**TOWN OF BROOKLYN
PLANNING AND ZONING COMMISSION
Regular Meeting Agenda
Tuesday, November 16, 2021 6:30 p.m.**

- d. **Other Unfinished Business:**
 - 1. **SP 21-002:** Special Permit Application for Multi-Family Development (51 Condominium units) on south side of Louise Berry Drive (Assessor's Map 33, Lot 19), 13.5 acres, R-30 Zone, Applicant: Shane Pollack.

**TOWN OF BROOKLYN
PLANNING AND ZONING COMMISSION
Regular Meeting
Wednesday, November 3, 2021 6:30 p.m.**

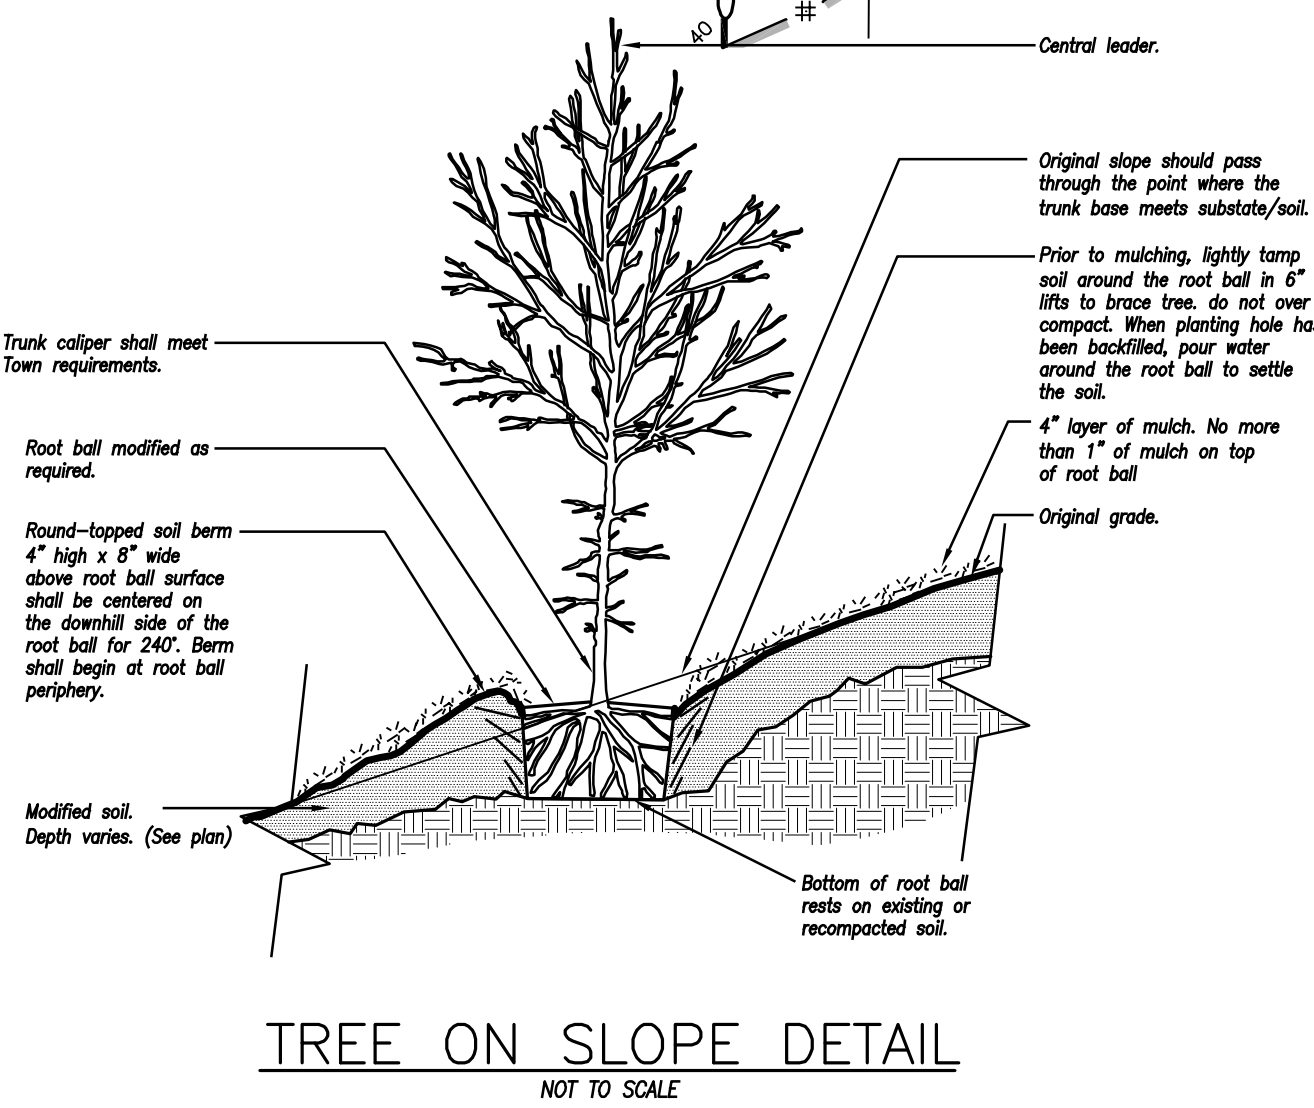
Response: Street lights will be full cutoff lantern-style fixtures and only 10øin height as shown on sheet 5. Although lighting has not been selected for the residences, the plans call for full cutoff fixtures for the buildings. We anticipate having sconce-style lighting over the garage doors and at the front entryø. Hydrants are shown on the plans (2 total).

SITE SIGN DETAIL
NOT TO SCALE

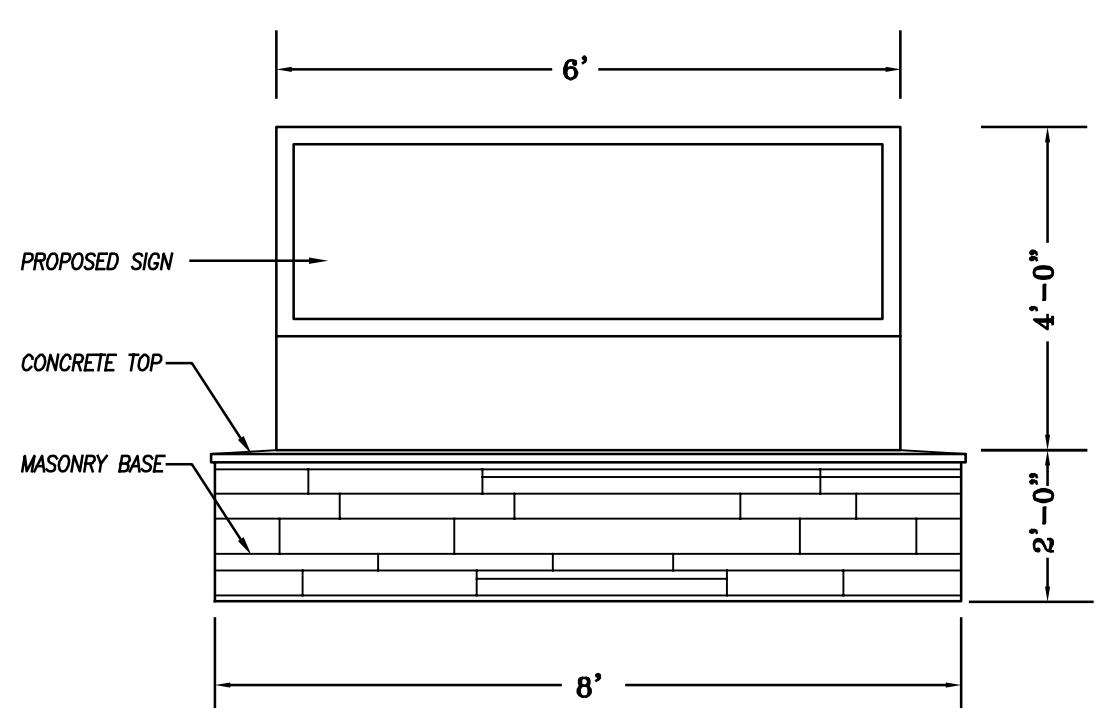
Response: The location of a proposed sight sign is shown and a detail added to the plans (sheet 5).
